DYER WHARF I-195 DESIGN PRESENTATION

2.2.2026

CV Properties LLC
DEVELOPMENT + INVESTMENT + MANAGEMENT

ROOF SCREEN

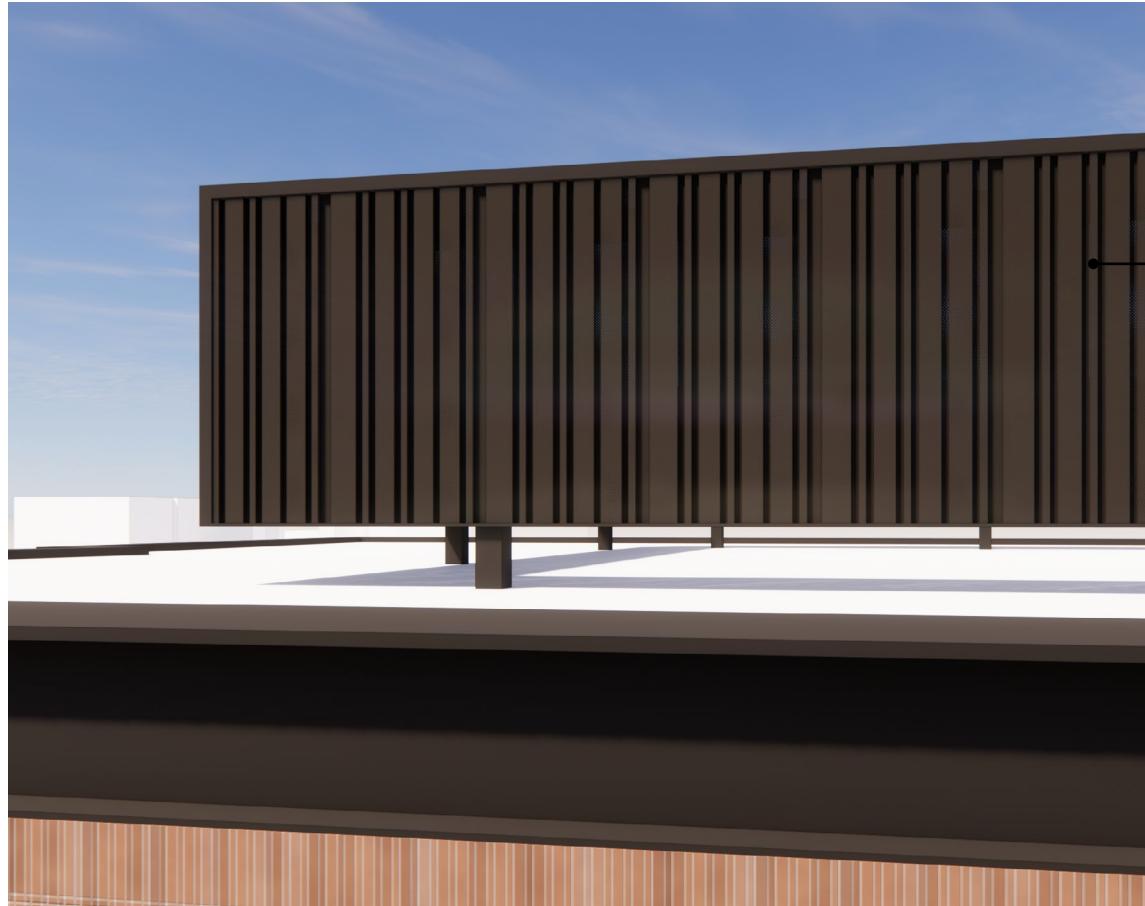
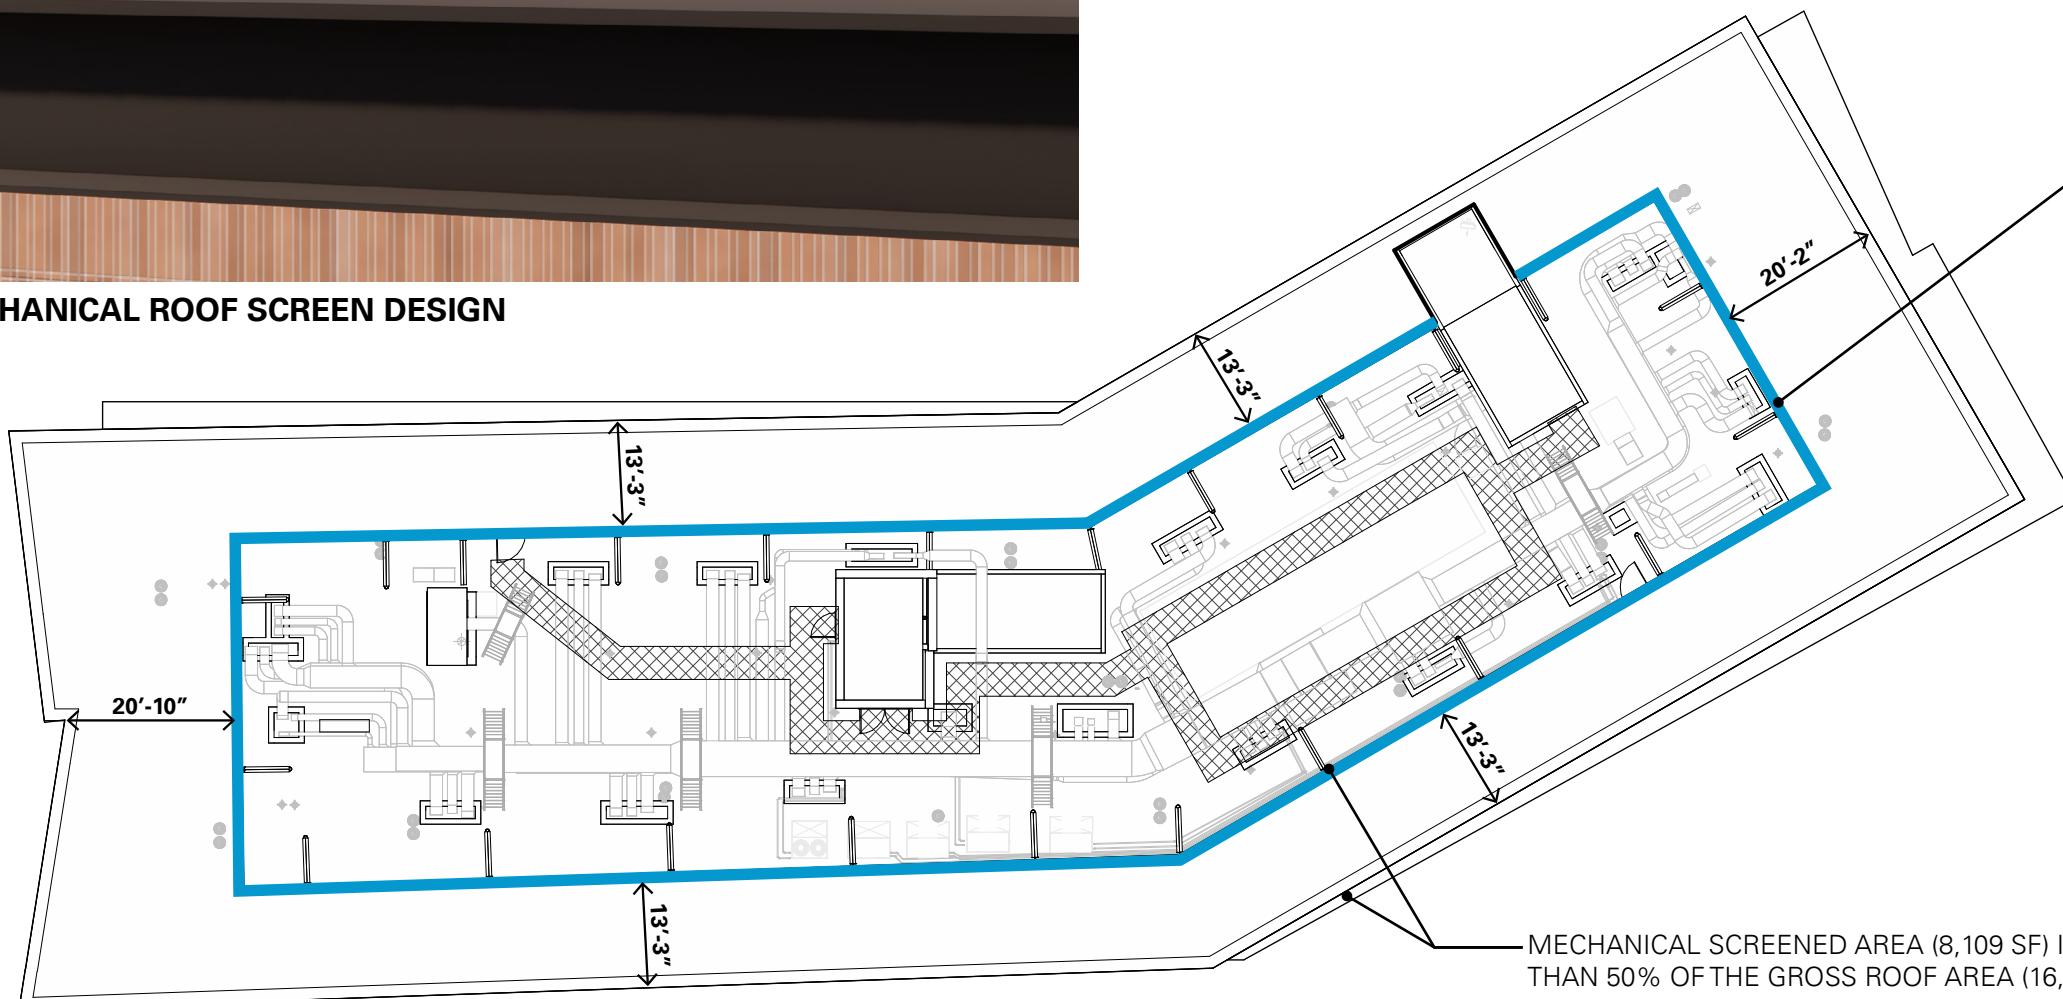
CURRENT DESIGN REMOVES PERFORATIONS
IN METAL ROOF SCREEN SHOWN IN
02.19.2025 I-195 PRESENTATION
